Addendum 001

PROJECT: UNC Pembroke RTU Replacements
Pembroke, NC 28372

PROJECT NO: Little Job Number: 5822131900
SCO Number: 24-28674-01A

ADDENDUM NO: 001

SHEET NUMBER
MD111

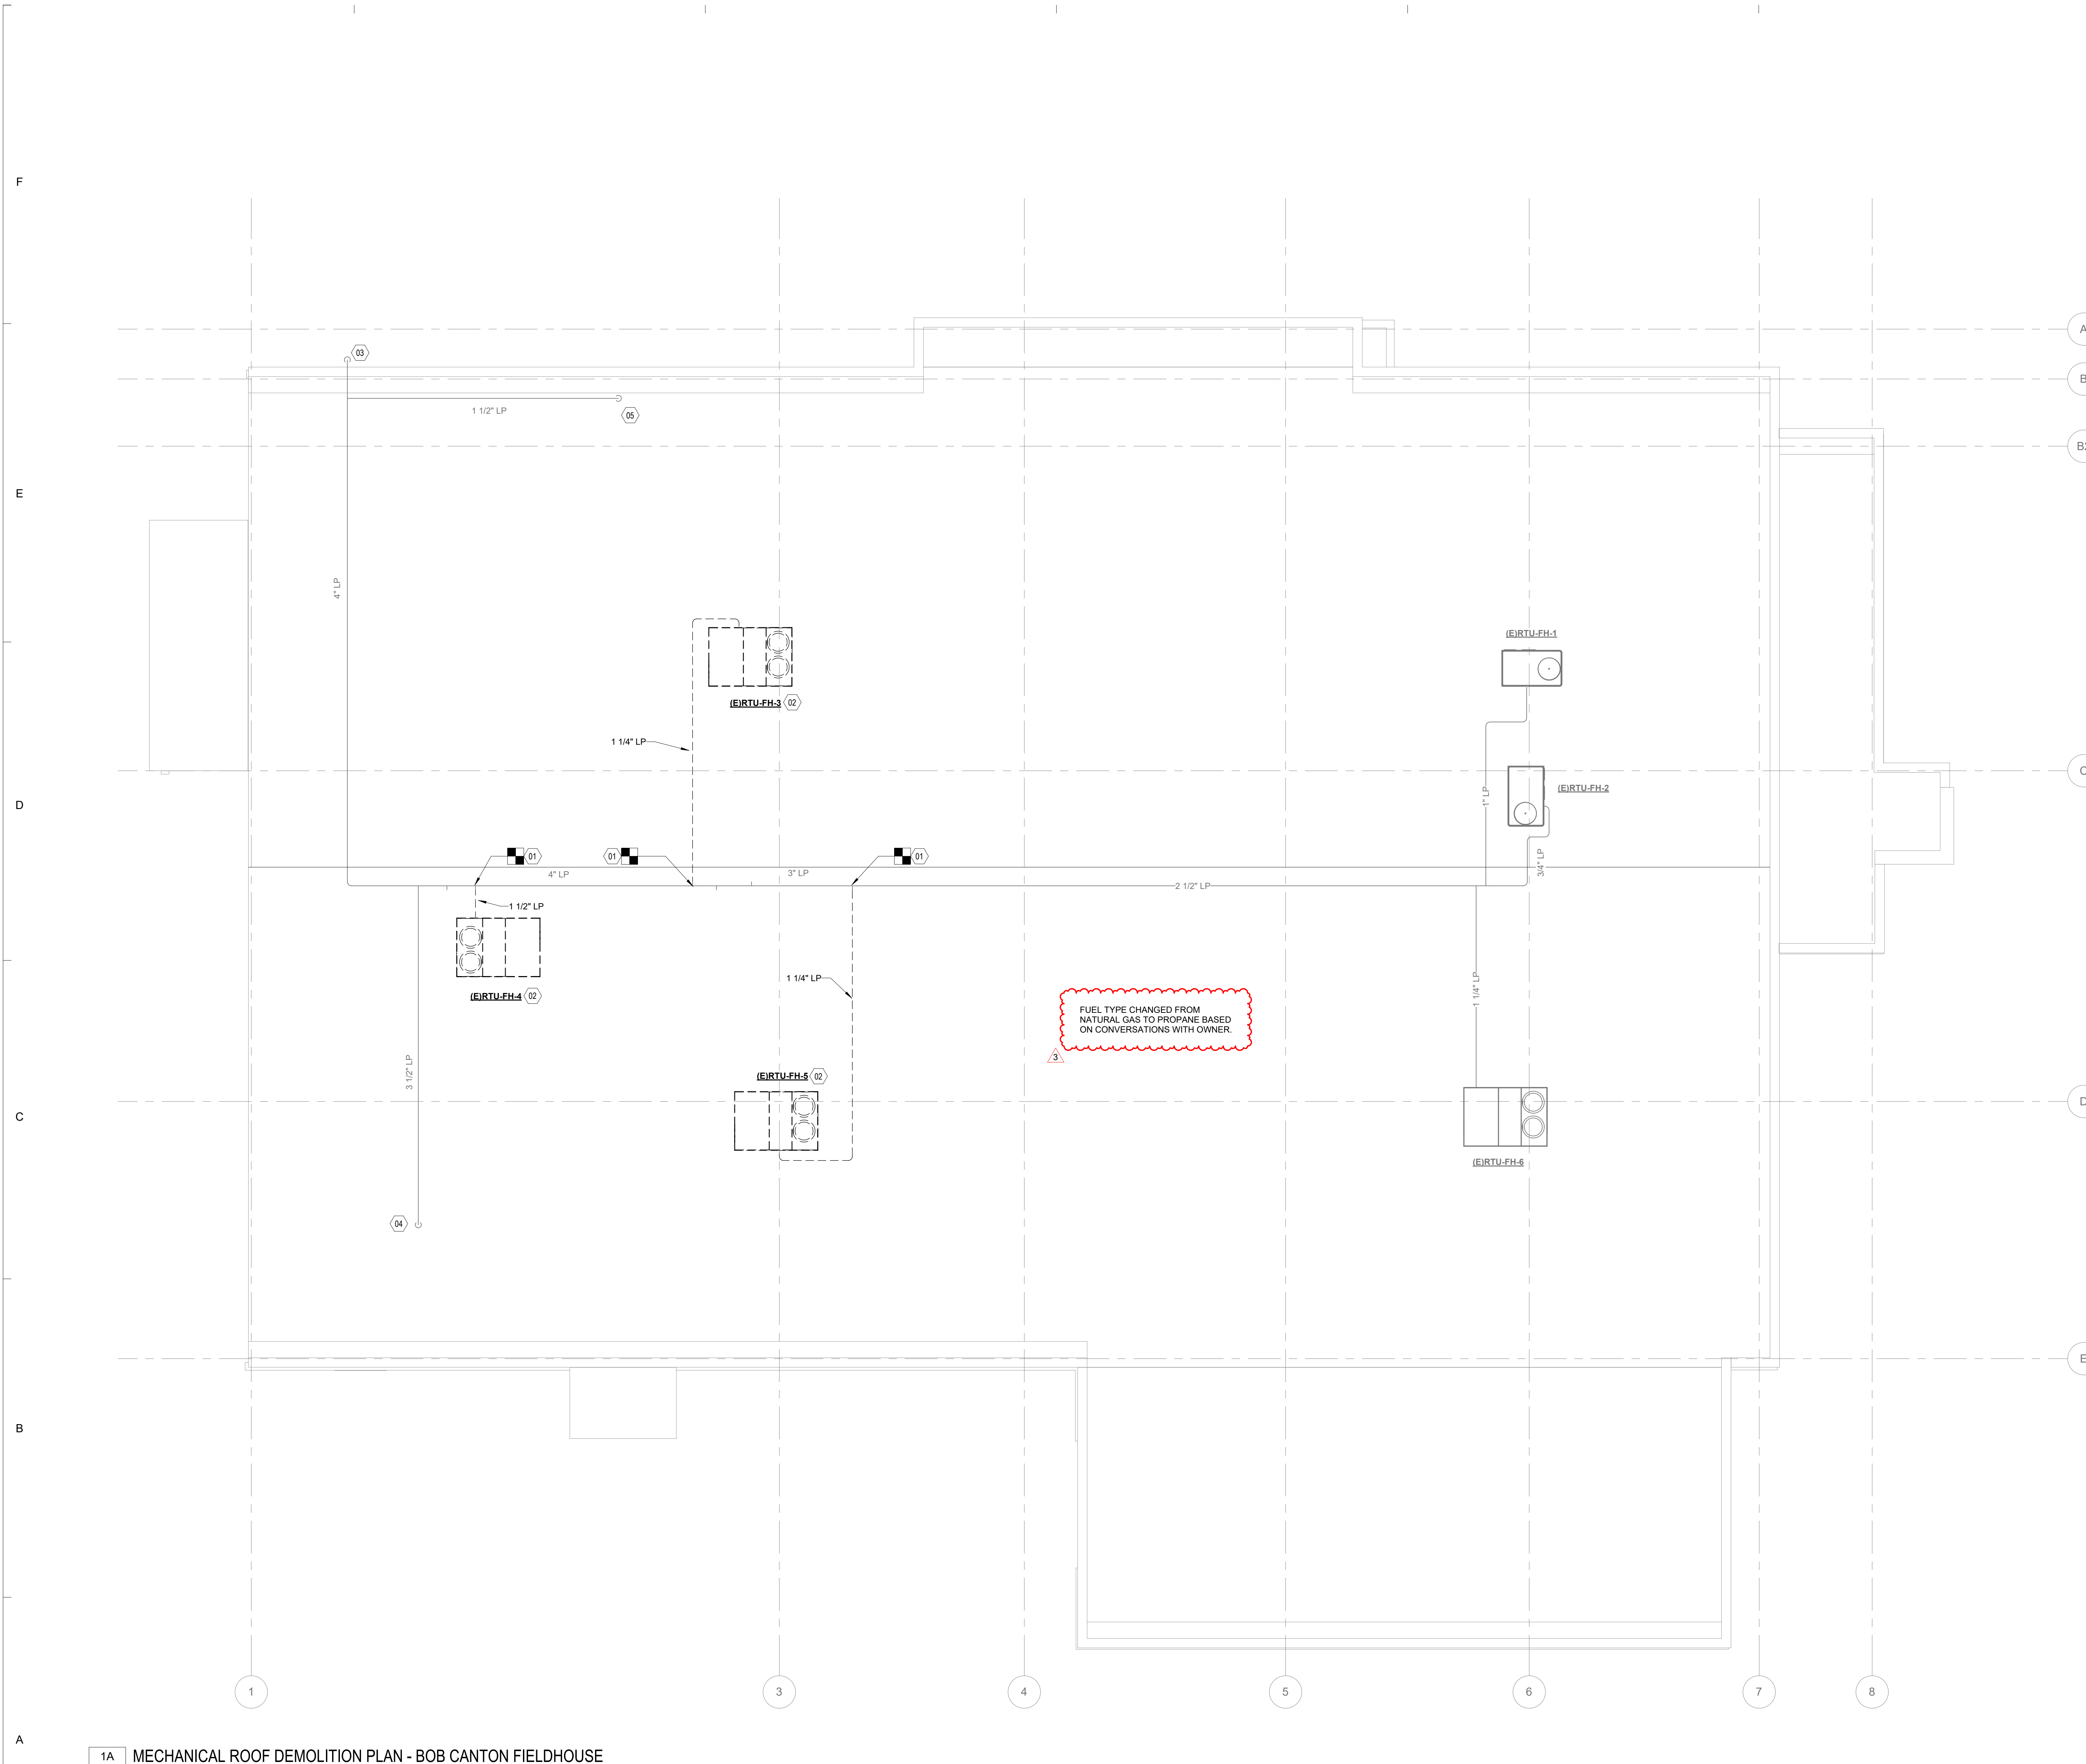
1. Drawings were revised to show LP gas piping on the Field House instead of Natural gas based on conversations with owner.
2. The existing RTUs had UV lights added to them with a separate power connection fed through the roof up to the RTUs. The existing power connection shall be capped and sealed watertight and abandoned in place. The new units will be "UV light ready", but UV lights will not be installed as part of this project. Units need to have adequate space in the cooling coil section to allow for UV lights and their mounting hardware to be installed in the future.
3. Hot gas reheat can either be modulating or staged.

- 01 REMOVE GAS PIPING AND ACCESSORIES AND CAP AT MAIN.
- 02 EXISTING ROOFTOP UNIT SHALL BE DEMOLISHED. EXISTING CURB SHALL REMAIN FOR RE-USE WITH NEW UNIT.
- 03 EXISTING GAS PIPING DOWN TO EXISTING BURRIED PROPANE GAS TANKS.
- 04 EXISTING GAS PIPING DOWN THROUGH ROOF TO EXISTING WATER HEATERS.
- 05 EXISTING GAS PIPING DOWN THROUGH ROOF TO EXISTING DRYERS.

SHEET NUMBER M111

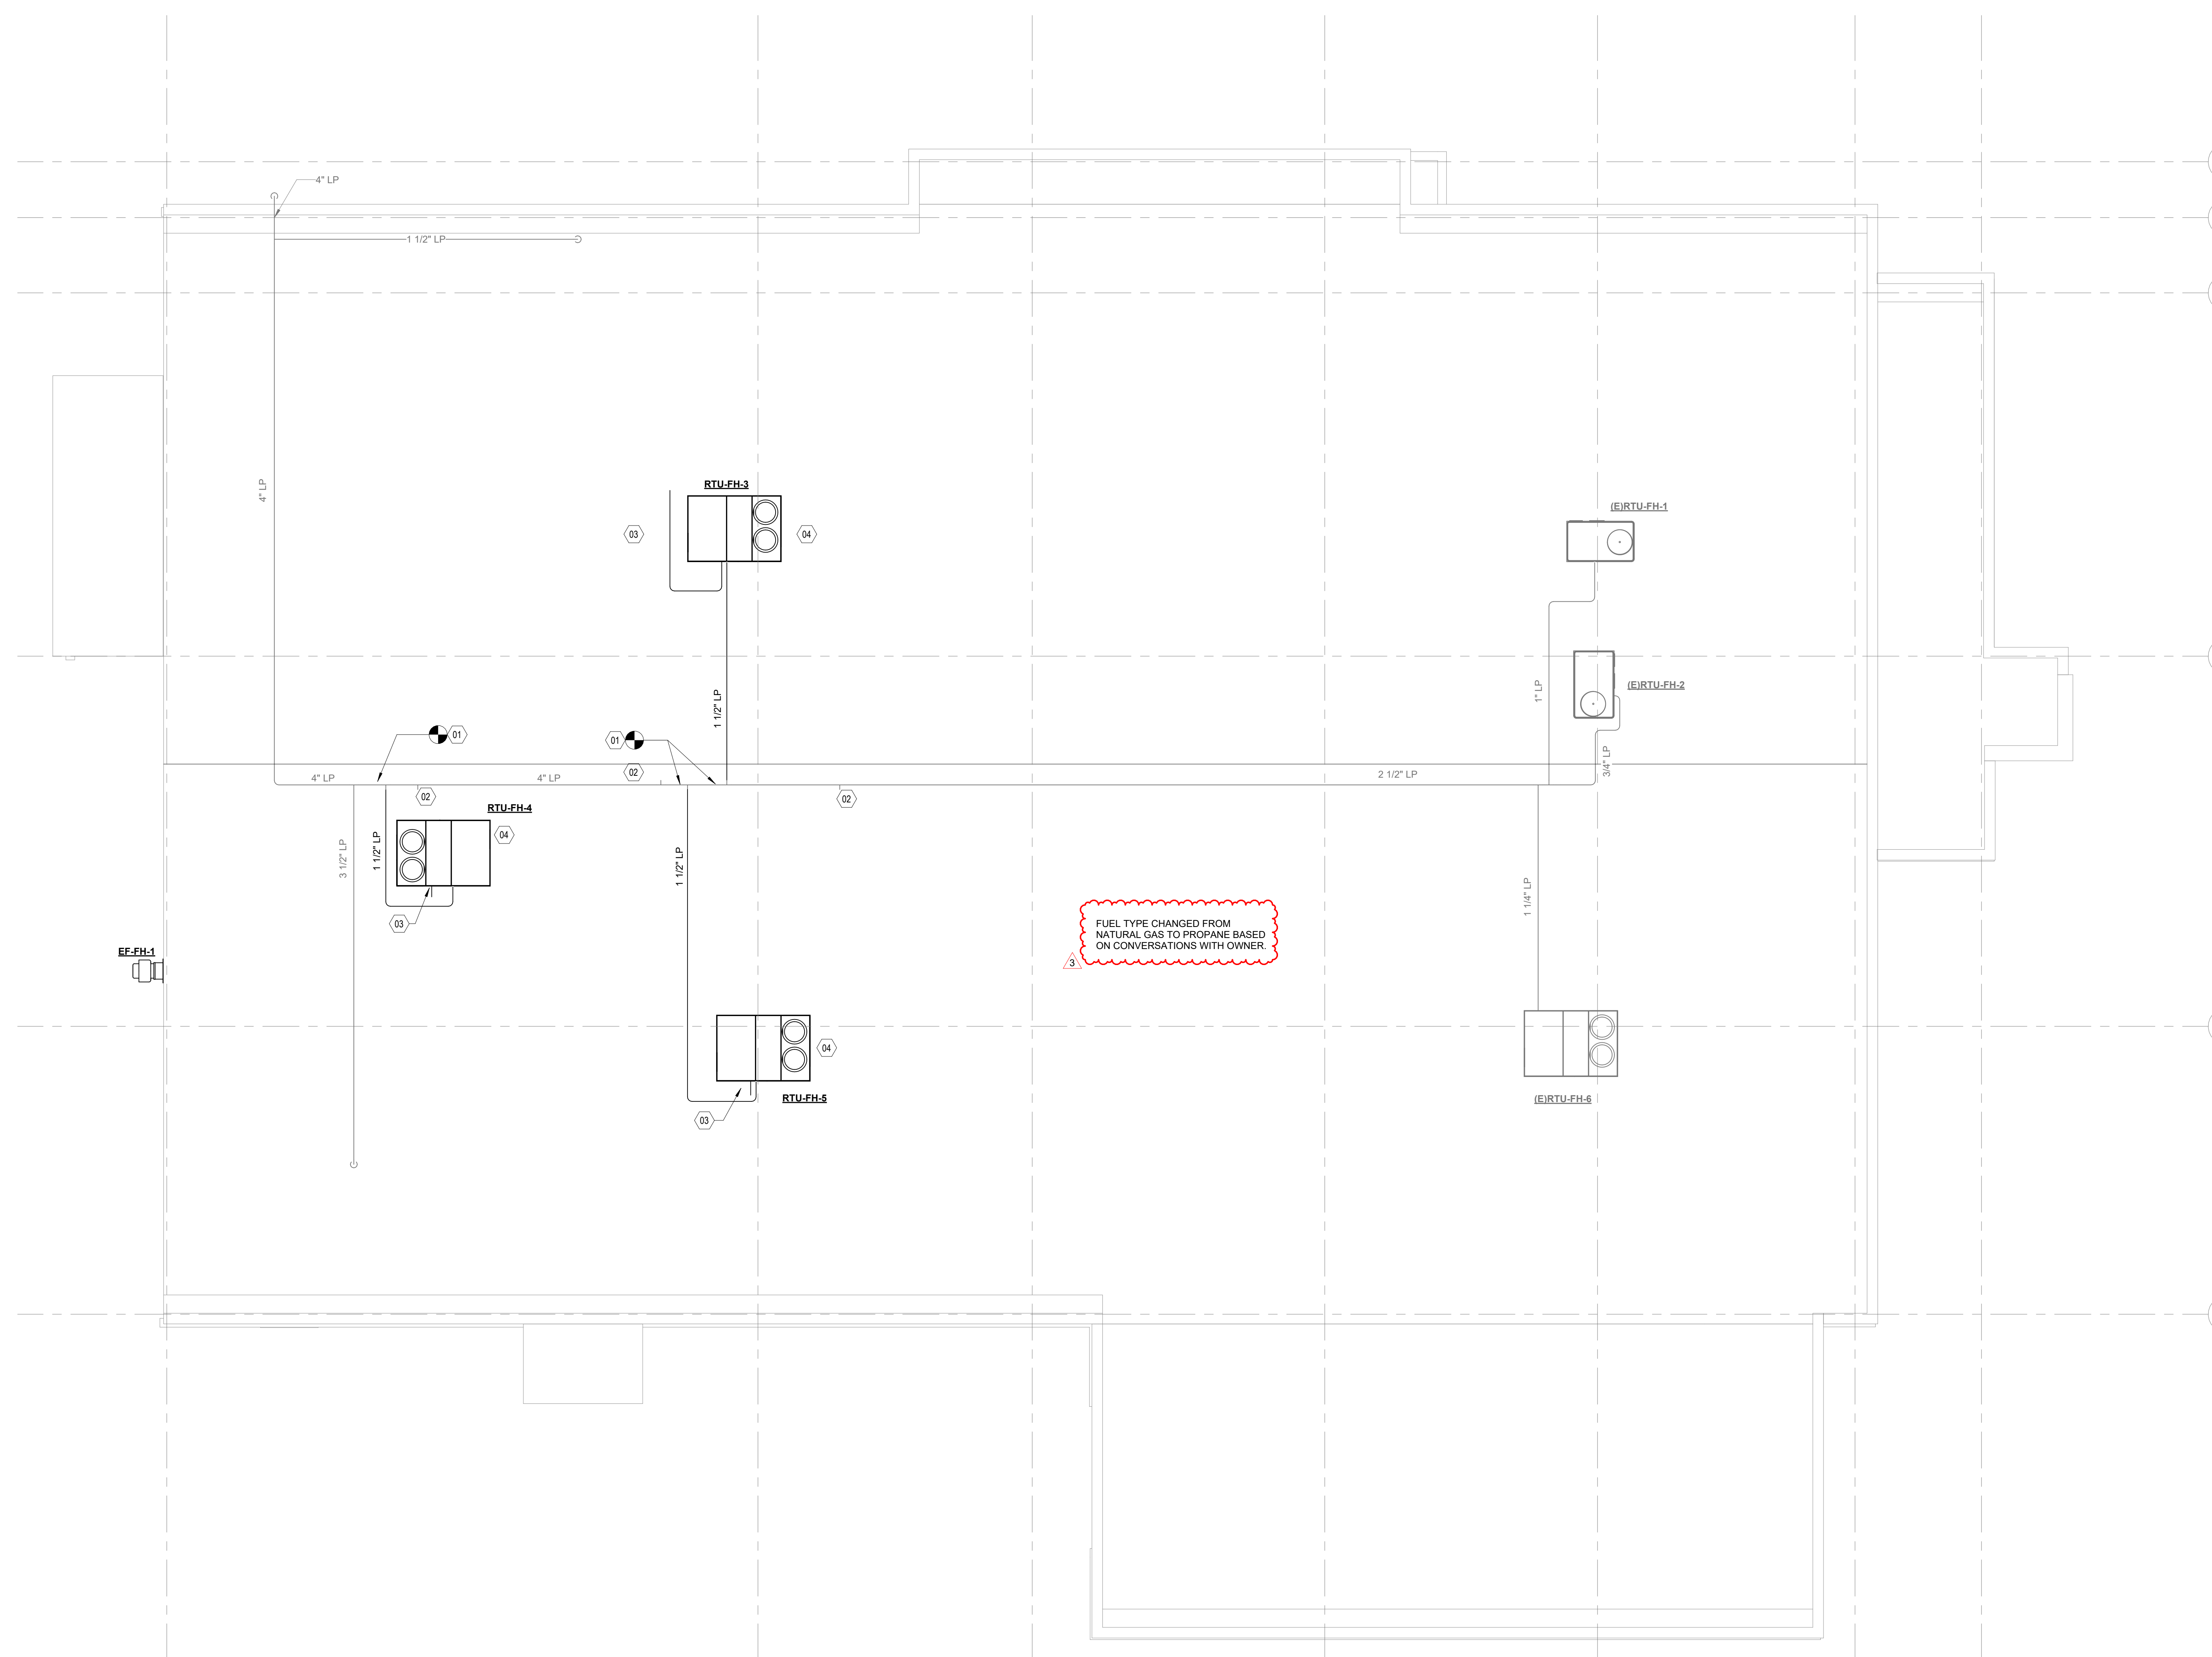
FUEL TYPE CHANGED FROM NATURAL GAS TO PROPANE BASED ON CONVERSATIONS WITH OWNER.

- 01 CONNECT NEW GAS PIPING TO EXISTING AT LOCATION SHOWN.
- 02 CAP EXISTING GAS TAP.
- 03 ROUTE CONDENSATE DRAIN PIPING TO STANDING SEAM ROOF SECTION WITH CLEAR PATH TO ROOF GUTTER.
- 04 INSTALL NEW RTU ON EXISTING ROOF CURB. PROVIDE ADAPTER AS NECESSARY.
